IDAP REPORT

Property:	38 Myrna Road STRATHFIELD Lot 22 in DP 14613 DA2021.148
Proposal:	Demolition of existing structures, tree removal and construction of a two (2) storey dwelling house with basement and detached outbuilding
Applicant:	ES Design
Owner:	J & S Obeid
Date of lodgement:	24 June 2021
Notification period:	6 to 20 July 2021
Submissions received:	Nil
Assessment officer:	M Rivera
Estimated cost of works:	\$990,000.00
Zoning:	R2 – Low Density Residential - SLEP 2012
Heritage:	No
Flood affected:	Yes
Is a Clause 4.6 Variation Proposed:	No
RECOMMENDATION OF OFFICER:	APPROVAL

Figure 2: Site Plan

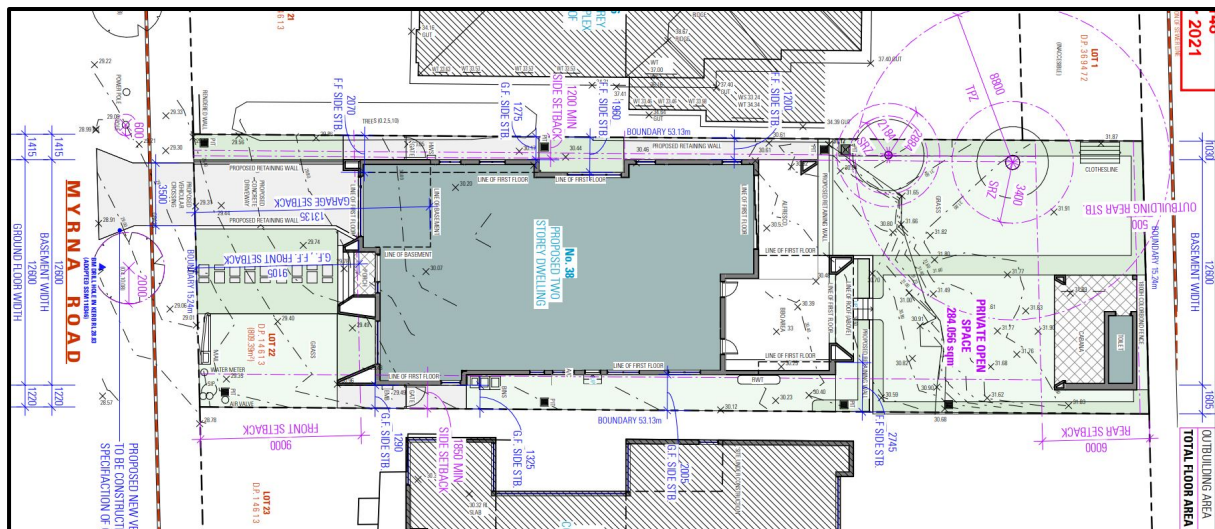
The proposed driveway crossing is 3.5m in width. A condition will be imposed to reduce the width of the new crossing to comply with the maximum driveway width control (3m).

It is further noted that no new canopy trees were provided by the development. Notwithstanding the retention of trees in the rear yard, a design change condition is recommended to provide at least one (1) canopy tree that is capable of reaching a mature height of at least 10m in the front yard. This ensures an improved balance of landscaped and hardscaped elements and compensates for the removal of four (4) site trees. Through the imposition of conditions the development is considered to enhance the existing streetscape and facilitate adequate open areas for deep soil planting and recreation for future occupants.

Driveway sight splays	A minimum 1m x 1m splay must be provided on both sides of the vehicular access, within the property boundary. The areas must be kept clear from obstructions and only allow ground cover landscaping, to maintain sight distances for pedestrians and motorists. Any front fence or gate opening adjustments required as a result of this splay must be illustrated on the plans lodged with the application for the Construction Certificate.
Southern side setback – changed to grassed turf area	The paved area shaded in blue must be deleted and changed to grassed turf areas to establish additional deep soil zones and to comply with the minimum landscaped area requirement under the DCP.

New tree/s in front setback	At least one (1) canopy tree must be provided in the front setback of the development. This tree must be of a species chosen from Strathfield Council's Recommended Tree List that is capable of reaching a mature height of at least 10m. The new planting/s must have a minimum container size of 50L and must be located more than 3m from any approved/existing building or structure.
Driveway crossing	The maximum width of the new driveway crossing at the property boundary and within the road reserve must be reduced to 3m to comply with maximum driveway width control under the DCP.

Figure 3: Basement Plan

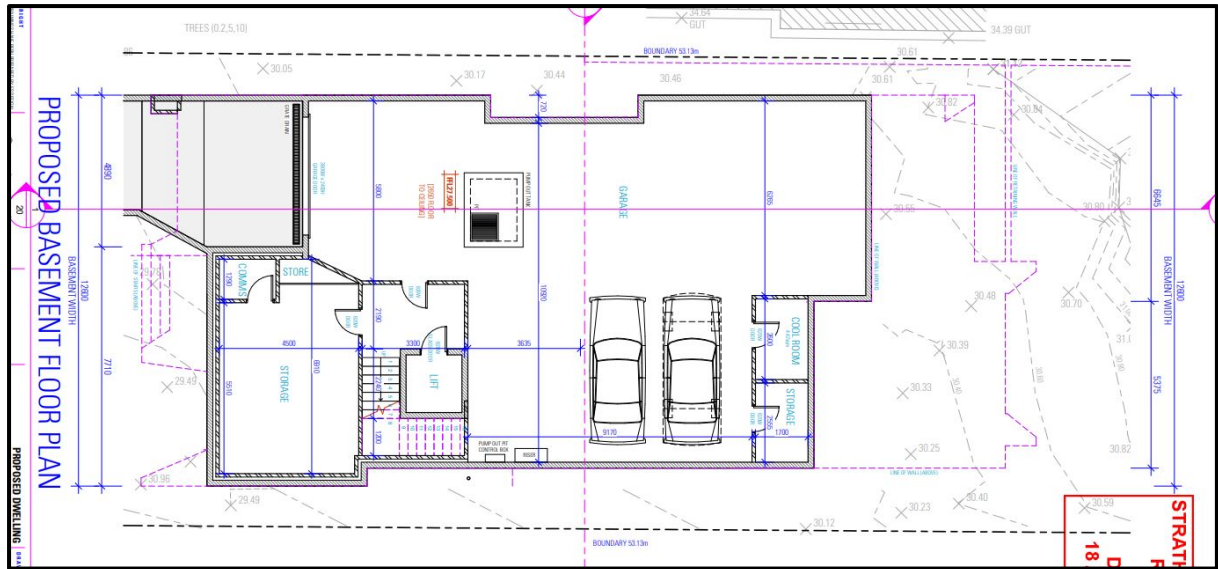
"There appears to be opportunities to re-configure the basement layout to further reduce the basement area."

A 1m by 1m splay is to be provided on both sides of the driveway crossing and within the property boundary."

The amended design now features reduced basement footprint and is considered a reasonable size that allows for forward entry and exit. Accordingly, Council's Traffic Manager offered no objections to the amended design of the proposal subject to the imposition of conditions.
